Notice of Proposed Amendment 2016-04

Maintaining aerodrome rules

CS ADR-DSN — Issue 3

RMT.0591 — 14.6.2016

Figure U-16. Isocandela diagram for taxiway centre line (15 m spacing), no-entry bar, and stop bar lights in straight sections intended for use in runway visual range conditions of less than a value of 350 m where large offsets can occur and for low-intensity runway guard lights, Configuration B

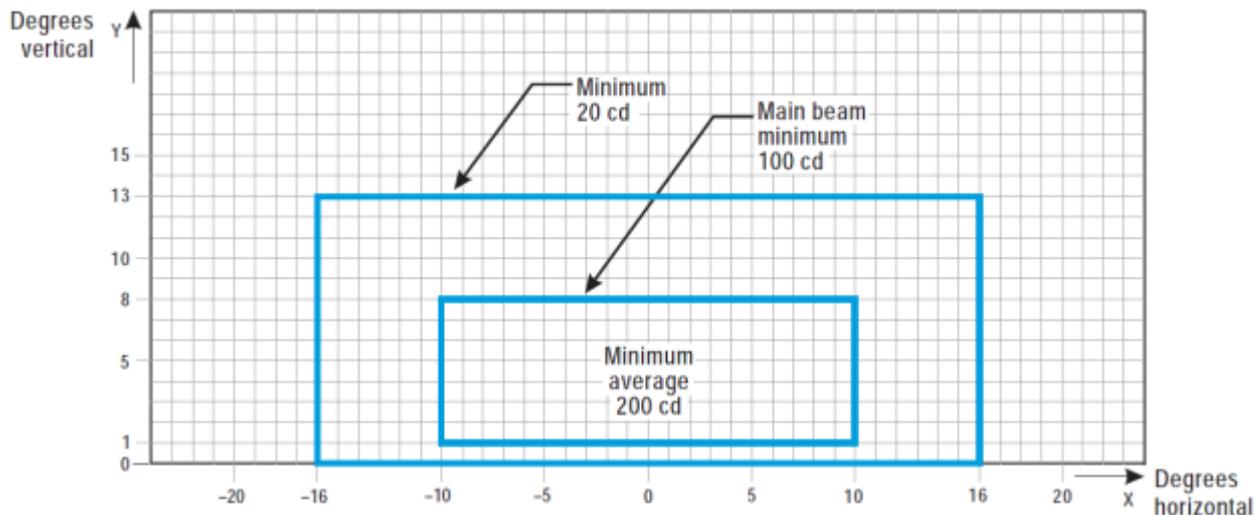
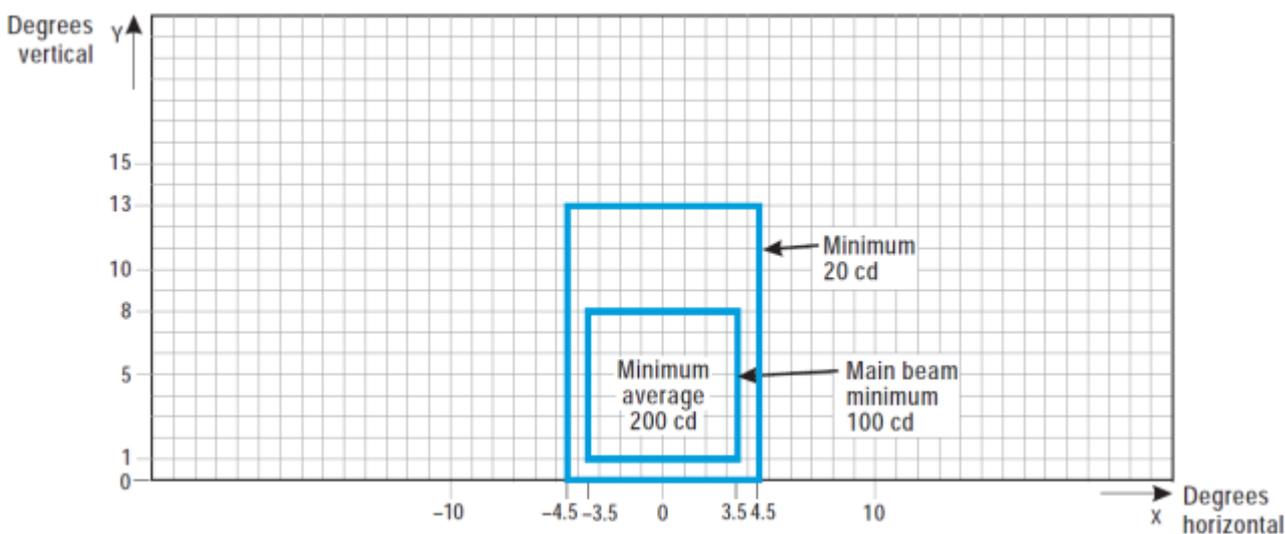
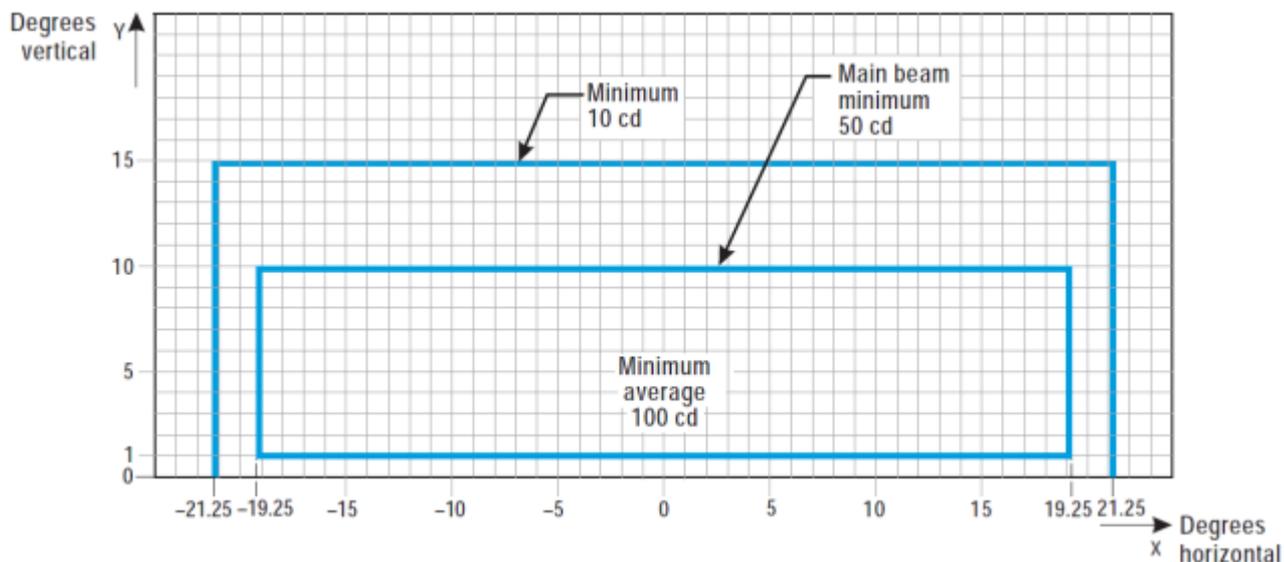
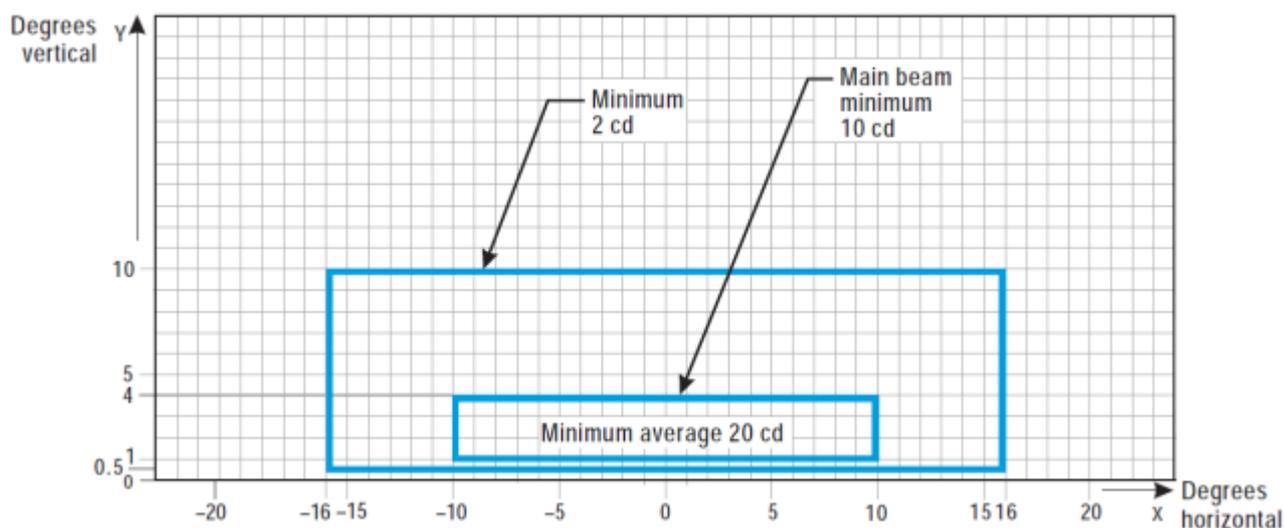
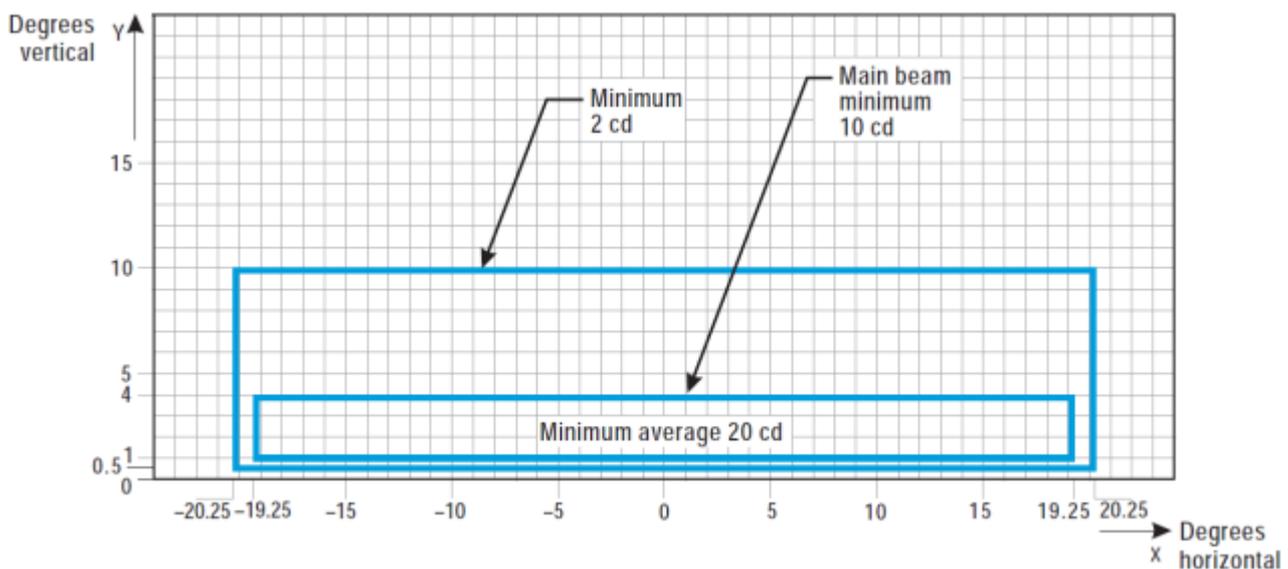
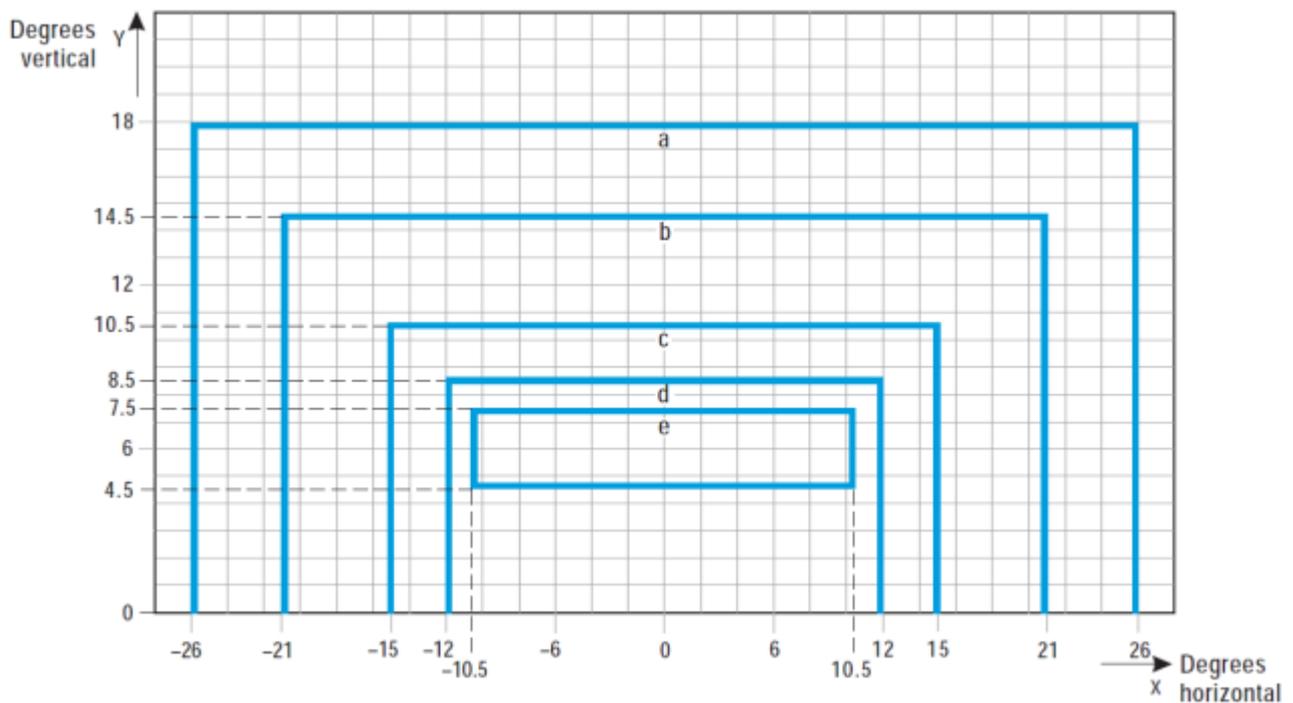
Reference to the 'no-entry bar' is added in the title of Figure U-16, U-17, U-18, U-19, U-20, U-21, U-22 and U-23.

Figure GM-C-1. Runway end safety area for a runway where the code number is 3 or 4

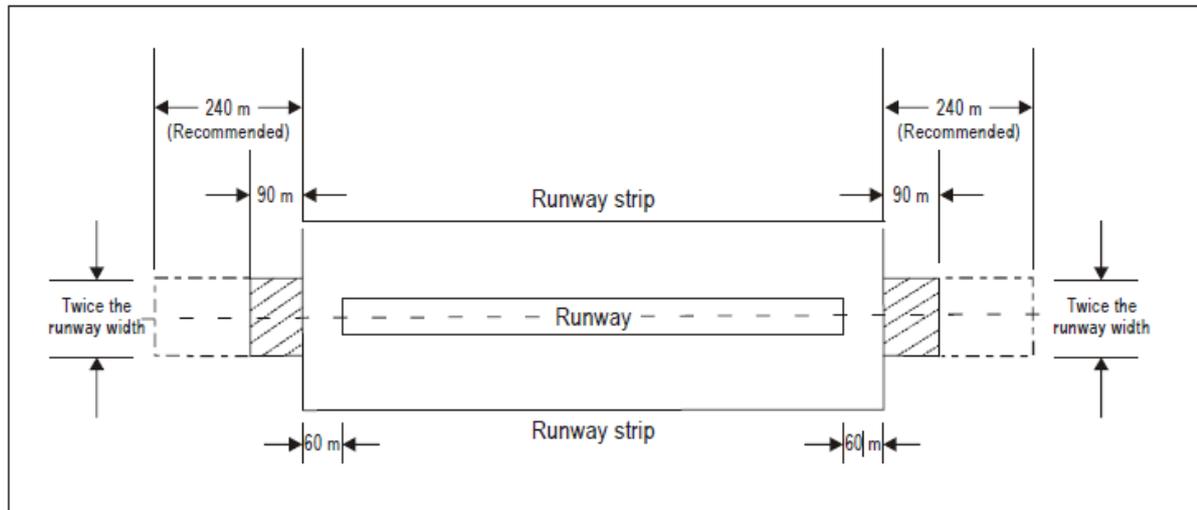
A new Figure GM-C-1 is provided in line with ICAO Annex 14 (Amendment 11).

Figure GM-D-1. Taxiway curve

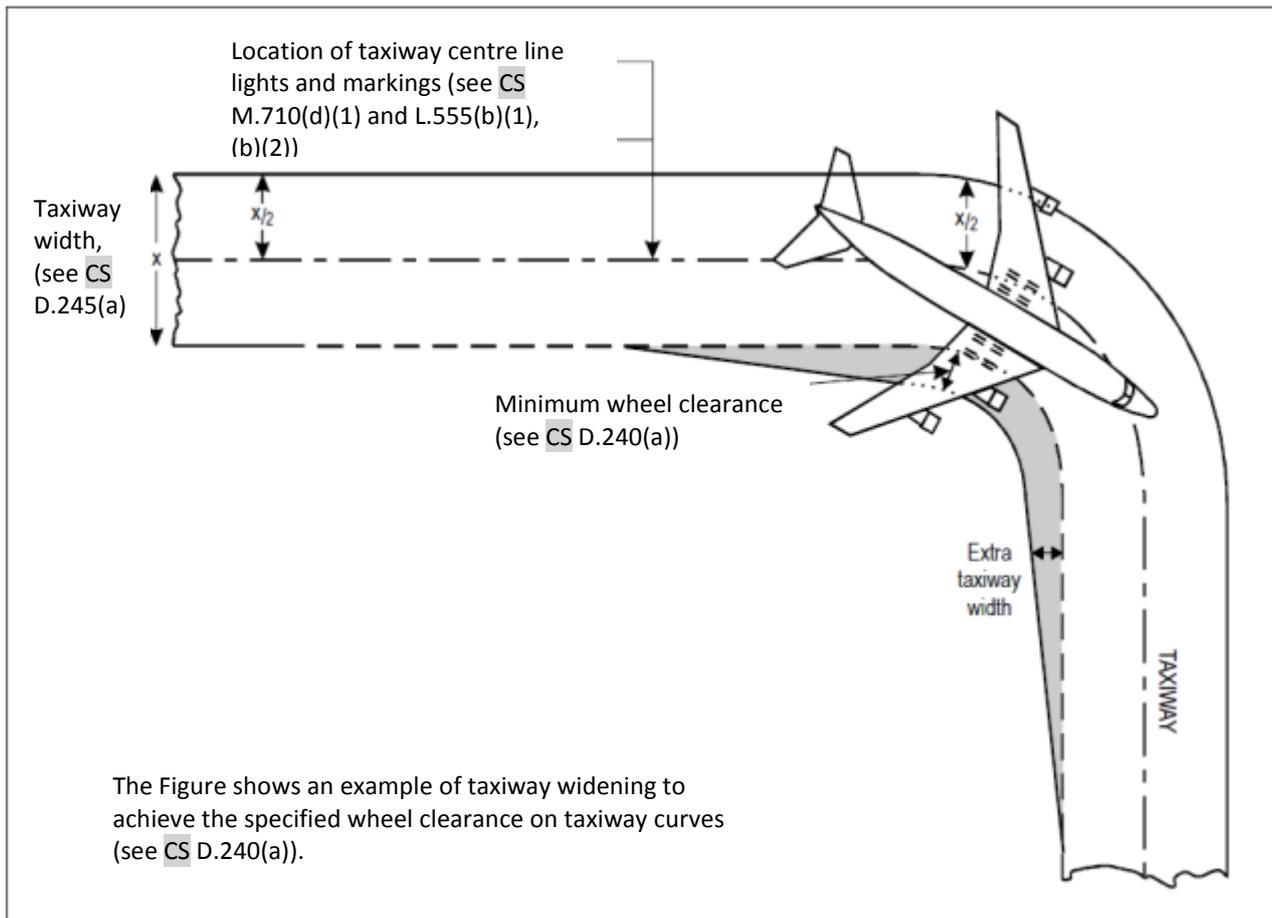
Corrections of typos are provided in the text as well as in Figure GM-D-1. Taxiway curve.
